Meeting Date: Tuesday 9 May 2017
Location: Council Chambers, Level 1A, 1 Pope Street, Ryde
Time: 5.00pm

NOTICE OF BUSINESS

Item		Page
1	CONFIRMATION OF MINUTES - Meeting held on 11 April 2017	1
2	118 BALACLAVA ROAD, MARSFIELD. LOT 8 DP 16216. Local Development Application for construction of two-storey boarding house containing 10 boarding rooms. LDA2016/0287.	5
3	1 STANSELL STREET, GLADESVILLE. LOT 1 in DP 6026. Local Development Application of demolition and construction of a 6 storey Residential Flat Building containing 23 apartments and three levels of basement car parking. LDA2016/0151	131
4	PLANNING PROPOSAL UPDATE - 176 BLAXLAND ROAD, RYDE	251

Section CC through building, showing location and extent of non-compliance with fill requirements.

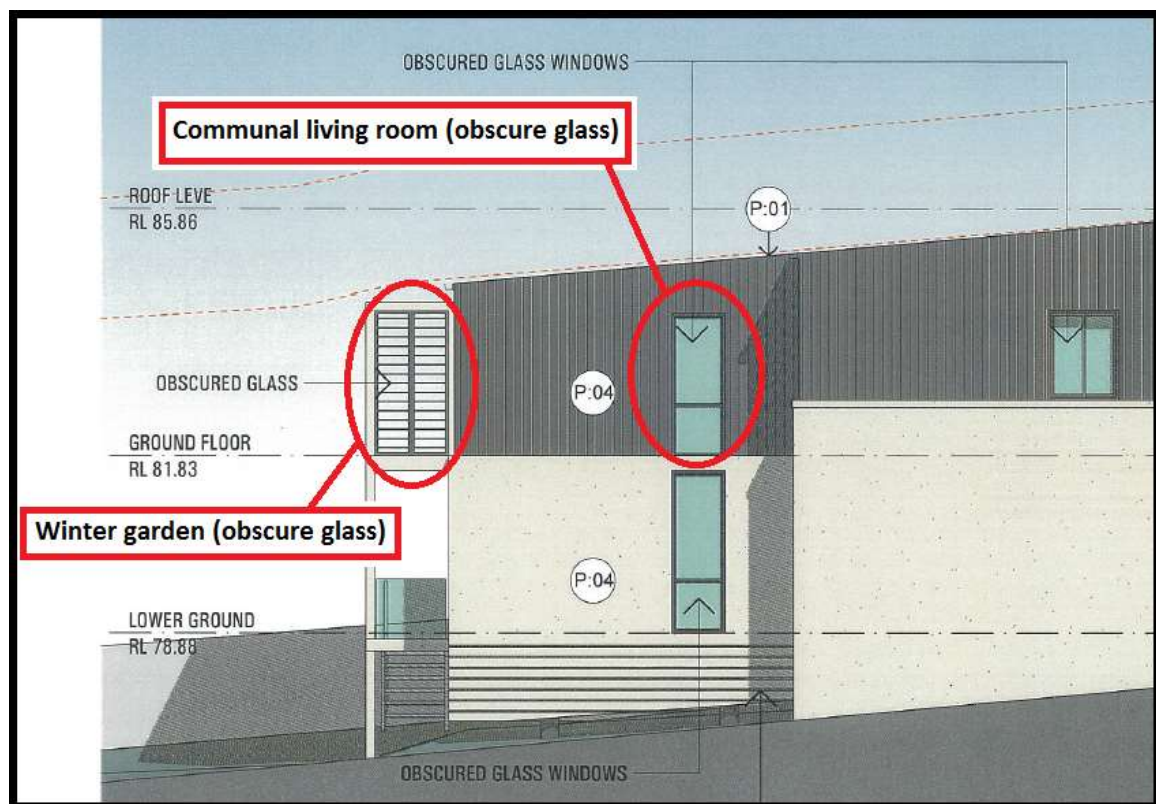
Although exceeding the maximum levels of fill within the building envelope, this non-compliance can be supported for the following reasons:

Figure 13: Section showing the extent of variation to the standard shown in blue.

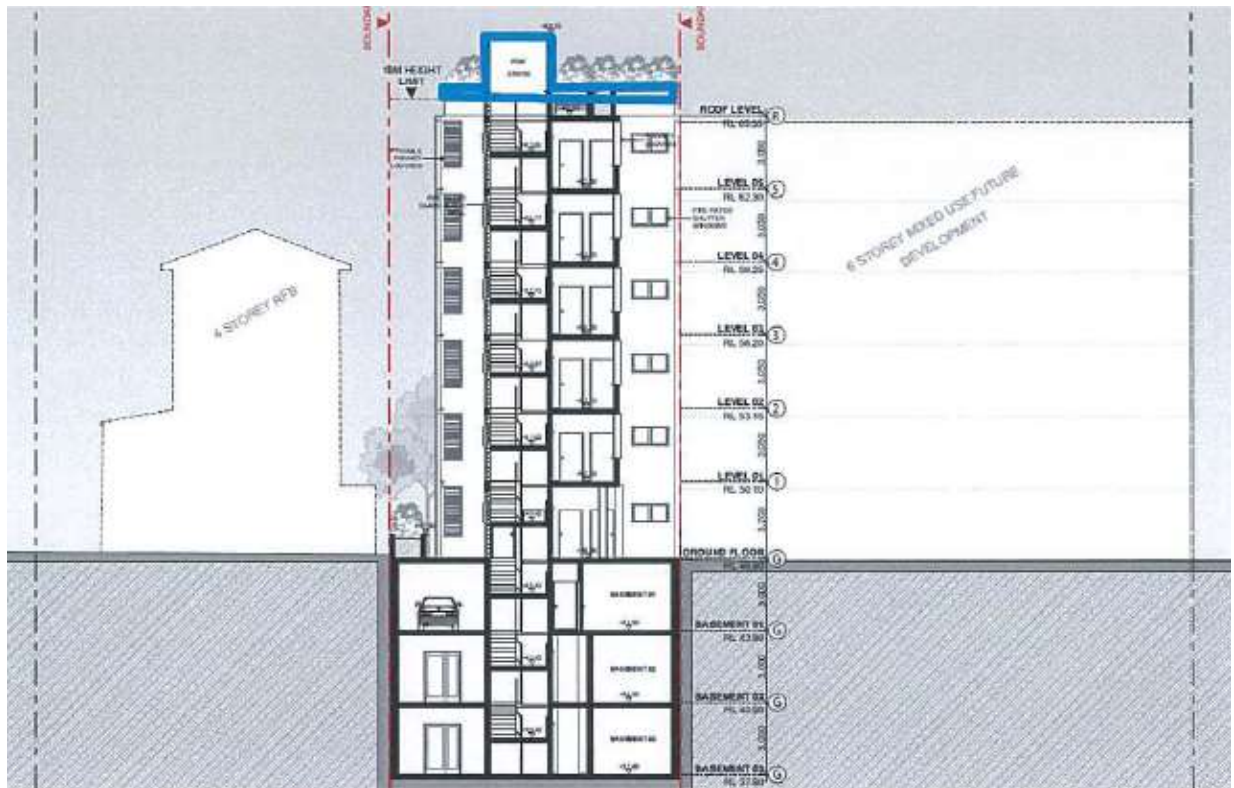
Under Clause 4.3, the height of a building on the site is not to exceed the maximum height of 19m. Building height is defined in Ryde LEP 2014 as meaning the vertical distance between (existing) ground level at any point to the highest point of the building, including plant and lift overruns, but excluding communication devices, antennae, satellite dishes, masts, flagpoles, chimneys, flues and the like. The building generally complies with the maximum height control except for the lift overrun and the balustrade to the rooftop communal open space. The extent of non-compliance is indicated in Figures 11, 12, 13 and 14 below:

Figure 17: Ground floor plan – separate pedestrian access provided.

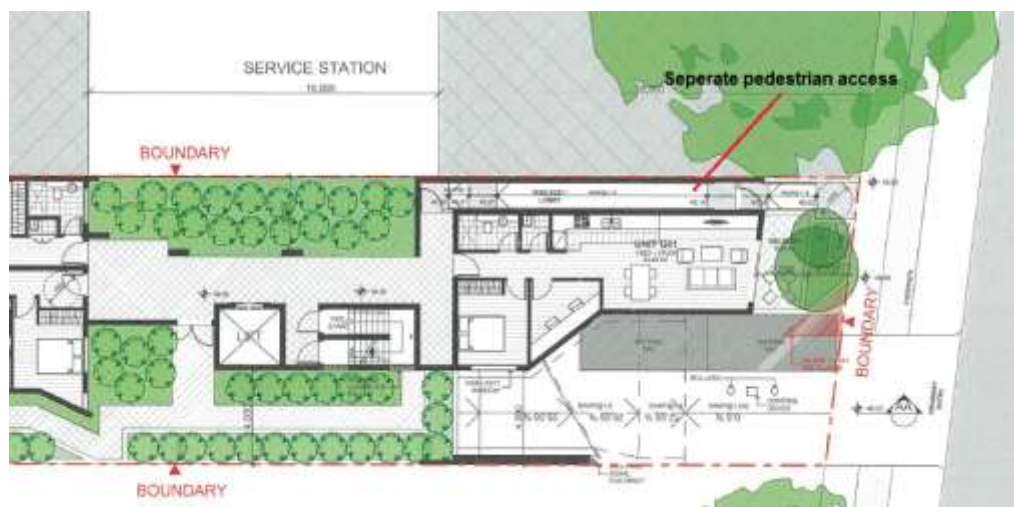
The colocation of the driveway and building entry is considered to present safety issues and is not supported (see earlier discussion).

Assessment Comment: The ground floor of the proposal was redesigned to separate the driveway and pedestrian access. Pedestrian access is now provided adjoining the western boundary and the driveway adjoins the eastern boundary. As such the URDP's concern has been addressed in regards to safety.

Figure 4.1 | Section AA showing the extent of variation to the development standard

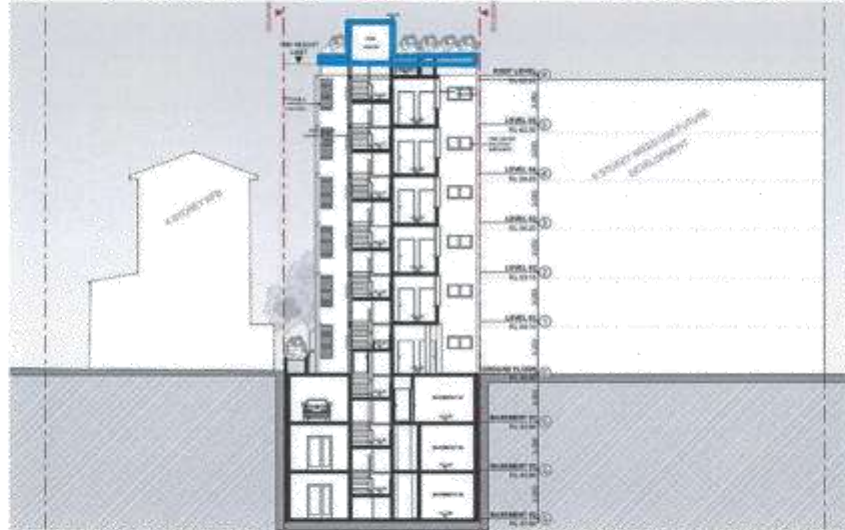
The proposed maximum variations to the height standard is 2.806m (RL 68.75) for the lift overrun and 1.488m (RL66.35) for the common open space roof top balustrade, as shown on Section BB and **Figure 4.1** below. **Figure 4.2** below, which is an extract from the amended architectural plans, prepared by Ghazi Al Ali Architect Pty Ltd, indicates the east elevation and building elements in excess of the 19m height plane.
